Agenda Item # 7

BOA-002778-2023

812, 816, and 824 West I-65 Service Road South

- A Height Variance request to allow a structure taller than 45-feet in a B-3, Community Business Suburban District

SITE PLAN

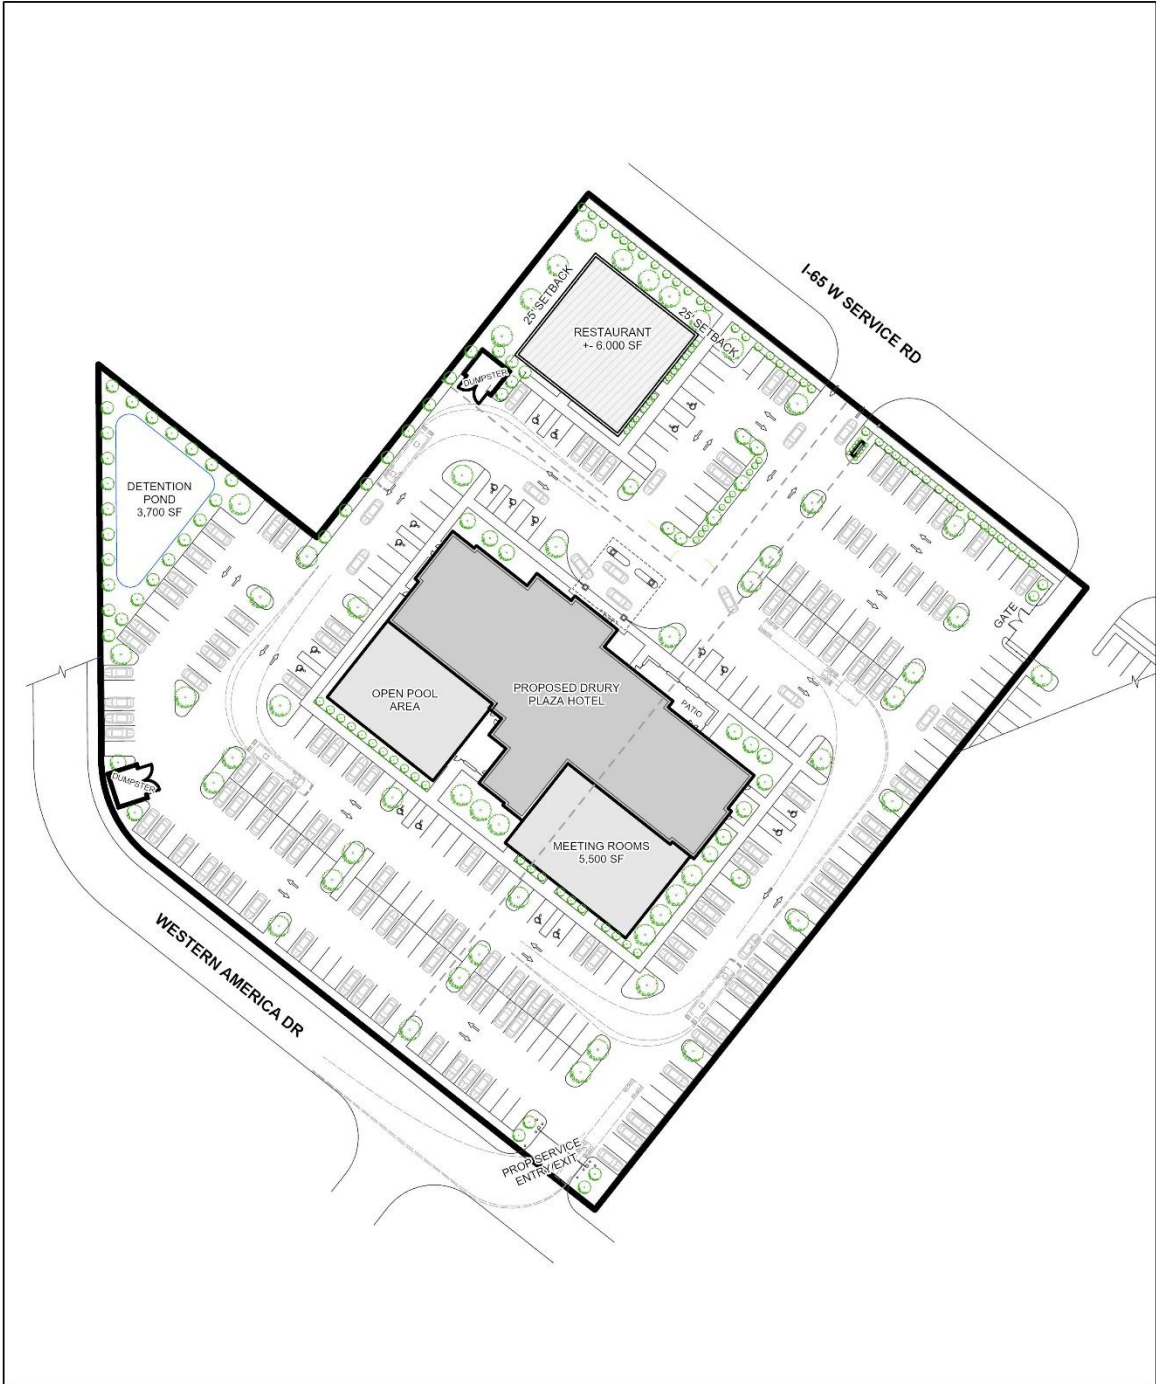
The proposed site plan submitted depicts a trash enclosure near the property line along Western America Drive. It should be noted that any dumpsters and enclosures must be relocated outside of any required setbacks, if approved.

The applicant states that the proposed hotel will have a total of 186 rooms, and the proposed restaurant will be 6,000 square feet; therefore, a total of 113 parking spaces are required. However, there is also 5,500 square feet of "meeting rooms" depicted on the site plan, which requires an additional 14 parking spaces, for a total of 127 required parking spaces. The site plan depicts a total of 294 parking spaces. At the time of permitting, a compliant photometric site plan will be required. Furthermore, the 167 parking spaces exceeding the minimum required amount will be required to be paved with an Alternative Paving Surface. Also, all parking spaces are required to have either curbing or bumper stops.

The subject site has an existing shared curb cut with a hotel to the East of the site. The proposed site plan depicts a gate and fence at this curb cut restricting access to the property. It appears that the proposed gate is less than 12-feet wide, and is therefore insufficient to allow vehicular traffic. If the proposed gate is for pedestrian access, it should be labeled as a pedestrian gate; or if the proposed gate is to serve vehicles, it should be revised to be a minimum of 24-feet wide to allow two-way traffic and insure that sufficient queuing spaces are available.

- 1) Revise the site plan to relocate the trash enclosure outside of all required setbacks;
- 2) Revise the site plan to correct the parking calculations to include the 5,500 square feet of meeting rooms;
- 3) Revise the site plan to depict curbing and/or bumper stops for all parking spaces;
- 4) Either revise the site plan to state the proposed gate will be for pedestrian access only, or make the gate a minimum of 24-feet wide with adequate queuing spaces;
- 5) Placement of a note on the site plan stating that each business (hotel and restaurant) is limited to a total of three (3) signs with no more than one (1) freestanding sign; and
- 6) Either completion of a one (1) lot Subdivision, or recording of an easement in Probate Court to allowed shared parking between the lots prior to the approval of any building permits for the proposed development.
